CALVERT CLIFFS
NUCLEAR POWER PLANT

SUBJECT: Calvert Cliffs Nuclear Power Plant
Unit Nos. 1 & 2; Docket Nos. 50-317 & 50-318
Supplement to License Amendment Request: Transition from Westinghouse
Nuclear Fuel to AREVA Nuclear Fuel

NON-PROPRIETARY SUPPLEMENTAL INFORMATION

Figure 1-1, Peak Cladding Temperature for a 0.087 ft² Break

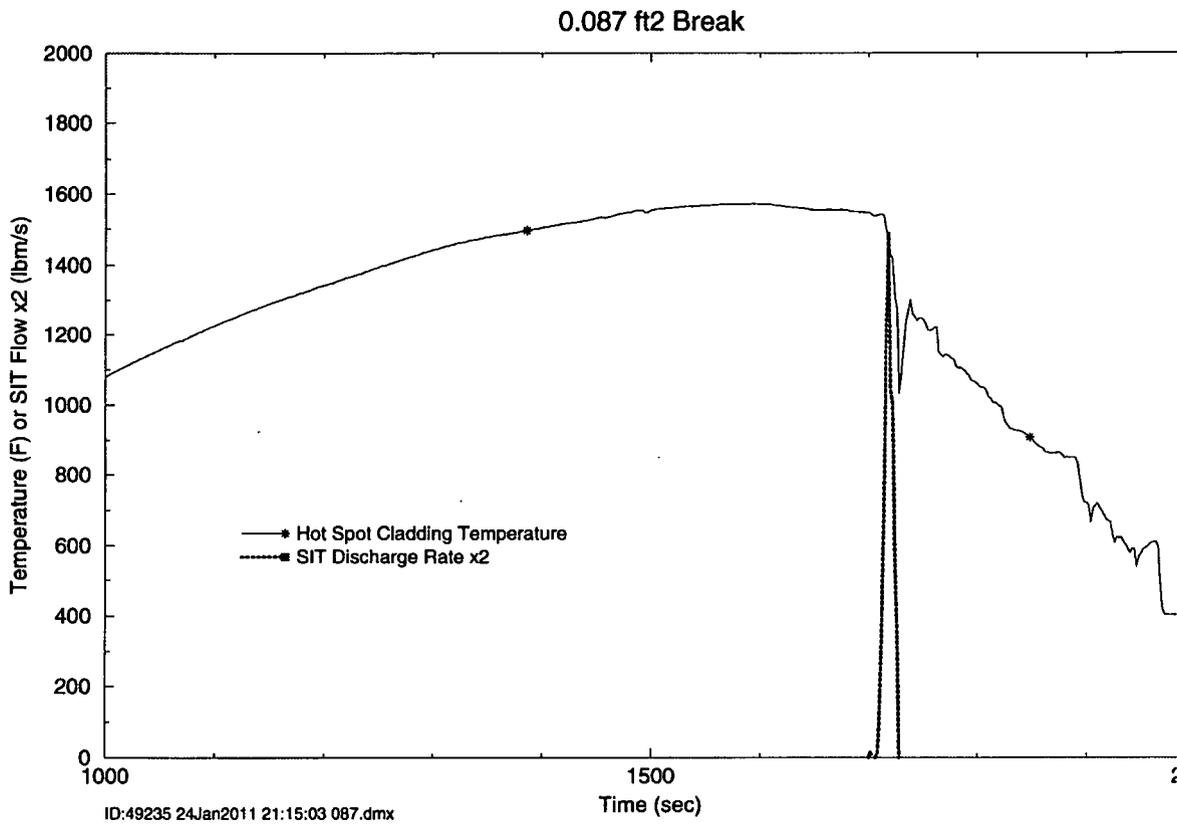
To further investigate the issue, AREVA performed additional SB LOCA studies, specifically, at 0.087 ft², 0.088 ft², and 0.089 ft². These break areas represent an increment in break diameter of 0.02 inches. Note the SIT injection rate was multiplied by 2 to demonstrate the timing dependence of SIT injection on the hot spot cladding temperature using a single y-axis scale.

The results of those cases are shown below in Figures 1-1 through 1-4. They produced lower peak cladding temperatures than the previously identified limiting case. The results are reasonable, with the time between peak cladding temperature occurrence and SIT discharge monotonically decreasing as break size increased – until, for the limiting case, the SIT discharge occurred almost simultaneously with peak cladding temperature. From the study, it can be seen that the cases performed encompassed the possible timing dependencies between peak cladding temperature and SIT injection. The scope of cases cover the phenomena where the escalation of cladding temperature was terminated by [] to the limiting case where the [] occurred essentially at the same time. For break sizes less than 0.09 ft² (4.1 inches), the model was biased to ensure []. For break sizes larger than 0.09 ft², [] with an associated reduction in peak cladding temperature. Thus, the supporting calculations confirm that within a change in break diameter of 0.02 inches, the 0.09 ft² break remains the limiting case.

Figure 1-4, Peak Cladding Temperature for a 0.090 ft² Break

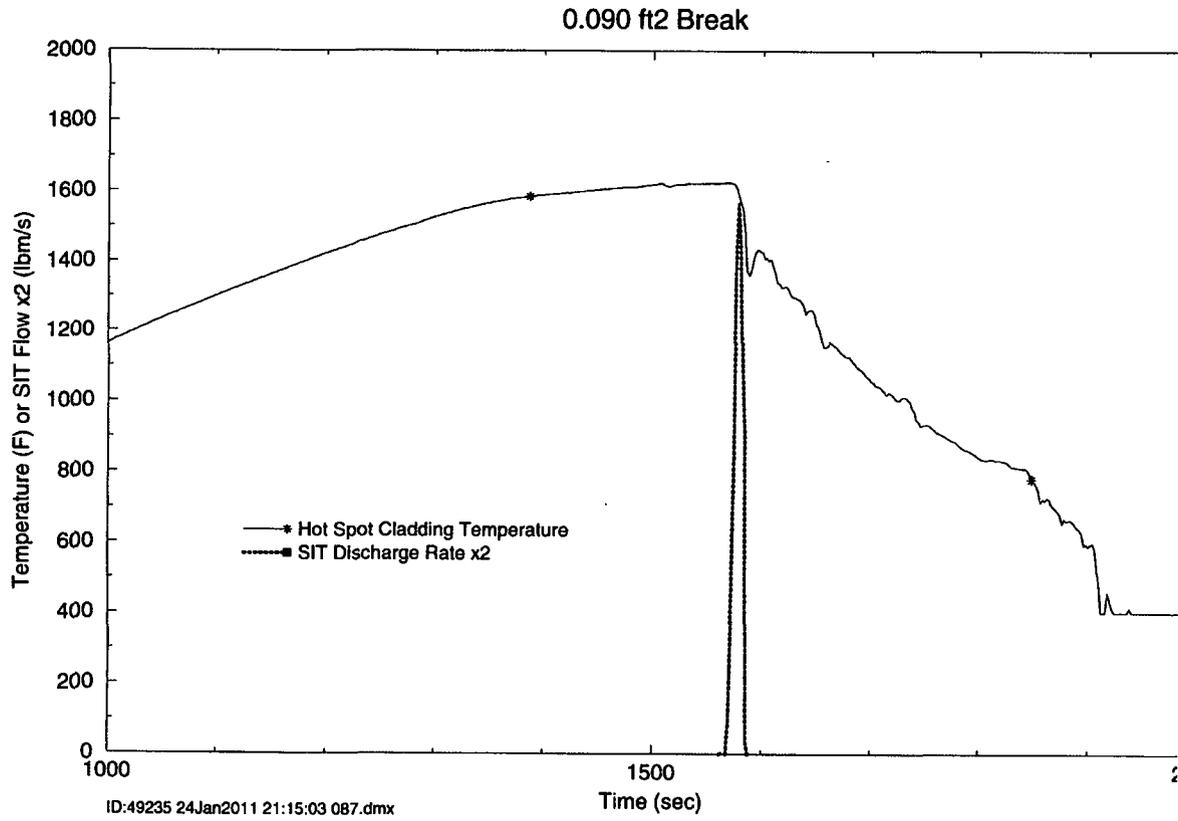
The cladding temperature for the published limiting case (break size of 0.09 ft²) turned over nearly coincidentally with the safety injection tank (SIT) discharge. The peak cladding temperature occurred [] after the start of the SIT discharge. However, SIT discharge did not occur for the next smaller break size (0.08 ft²). Given this information it could be postulated that the limiting peak cladding temperature could occur at a break size between 0.08 ft² and 0.09 ft².

PCT – Heat Structure 207–38

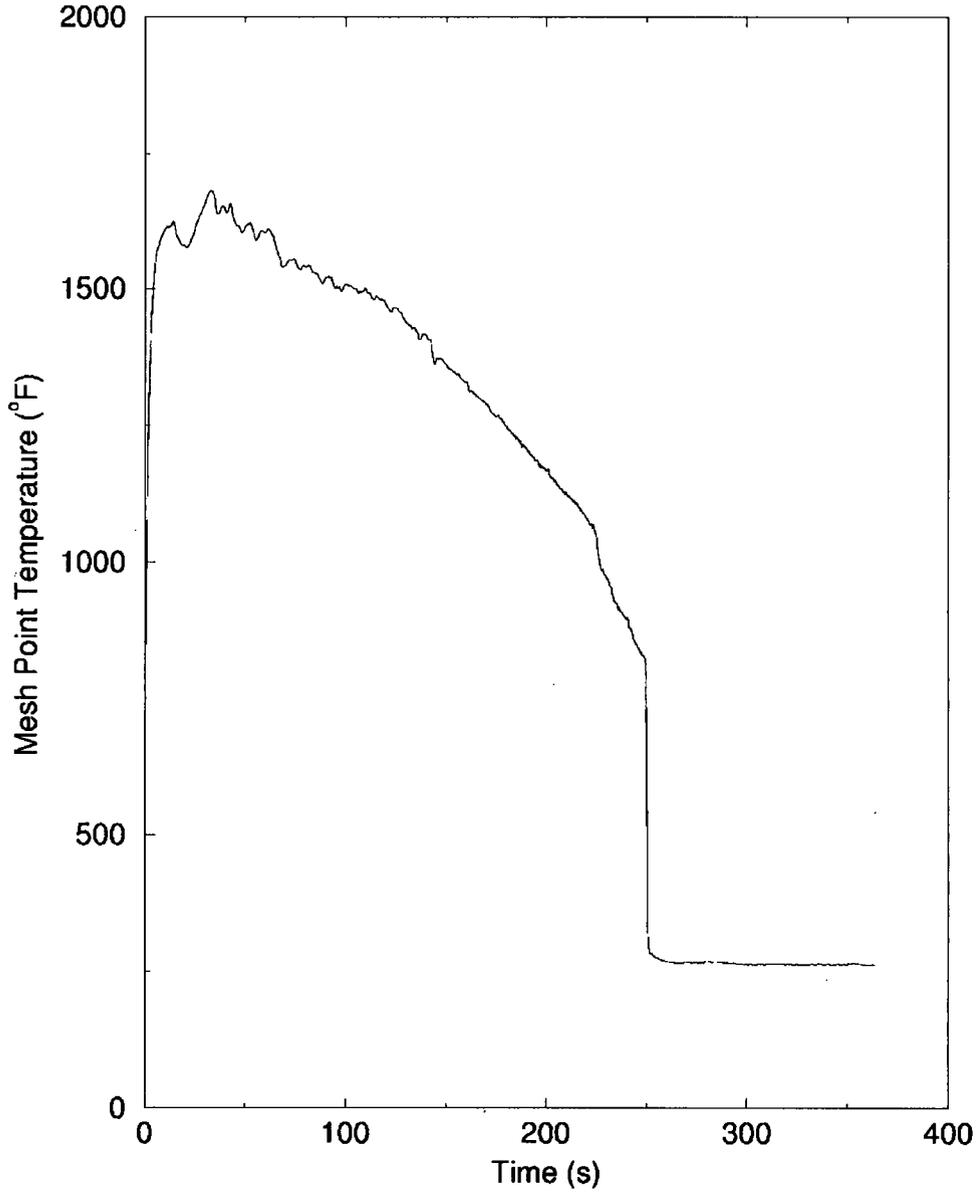
The figures below are provided in connection with discussions regarding the Response to Question 33 provided in Reference (1).

PCT = 1682.2 °F, at Time = 33.12 s, on 4% Gad Rod
